MIL-M-10323A(MU)
Amendment 4
30 April 1973
SUPERSEDING
Amendment 3
22 November 1971

MILITARY SPECIFICATION

MOUNT, TELESCOPE: M48

This amendment forms a part of Military Specification MIL-M-10323A(MU), dated 16 October 1967.

FIGURE 1

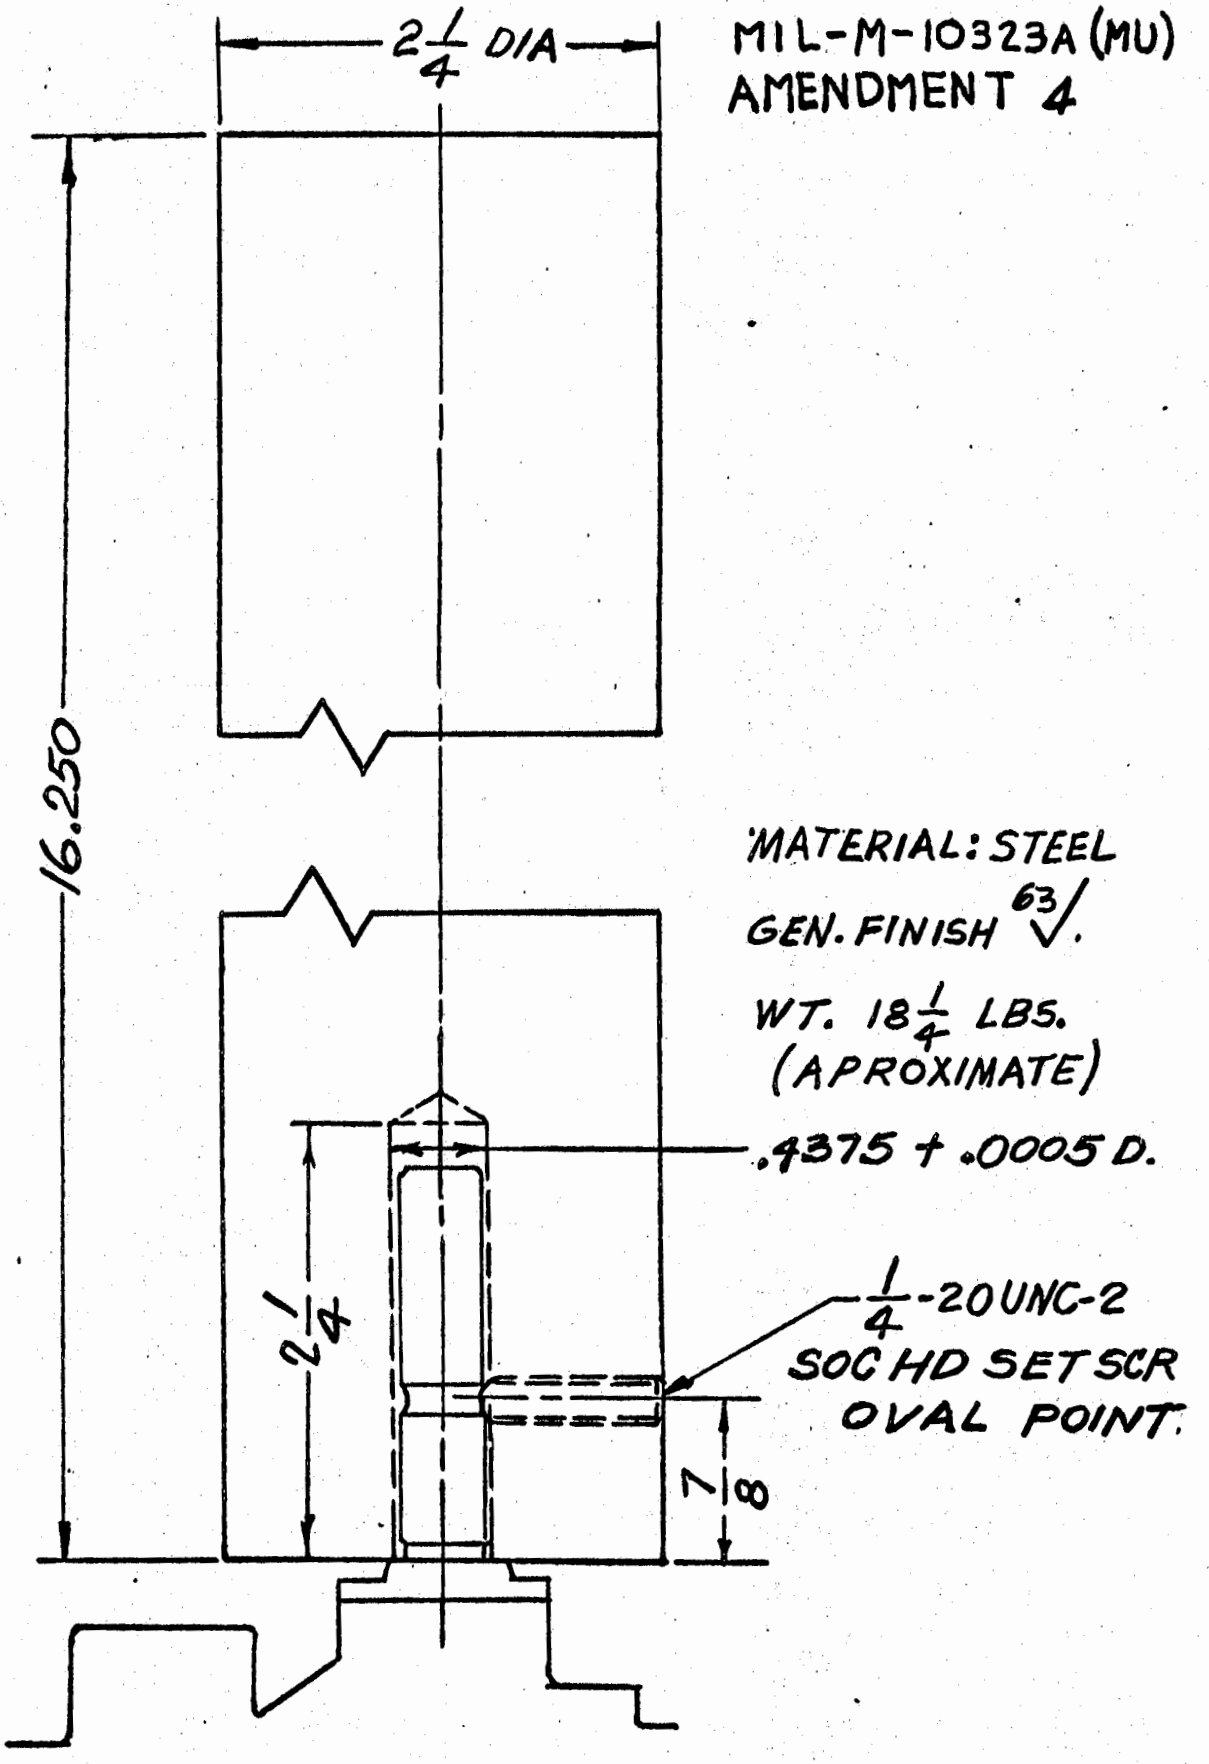
Paragraph 4.6.4 Accuracy: Add the following:

4.6.4 Accuracy.- The tests in 4.6.4.1, through 4.6.4.5 shall be performed utilizing a dummy load simulating Periscope, B.C. M65, with the approximate weight, outside dimension and configuration as shown in Figure I. The dummy load shall be mounted vertically on the mounting spindle of Telescope Mount: M48. Secure the dummy load to the spindle by means of its socket head set screw."

Add Figure 1.
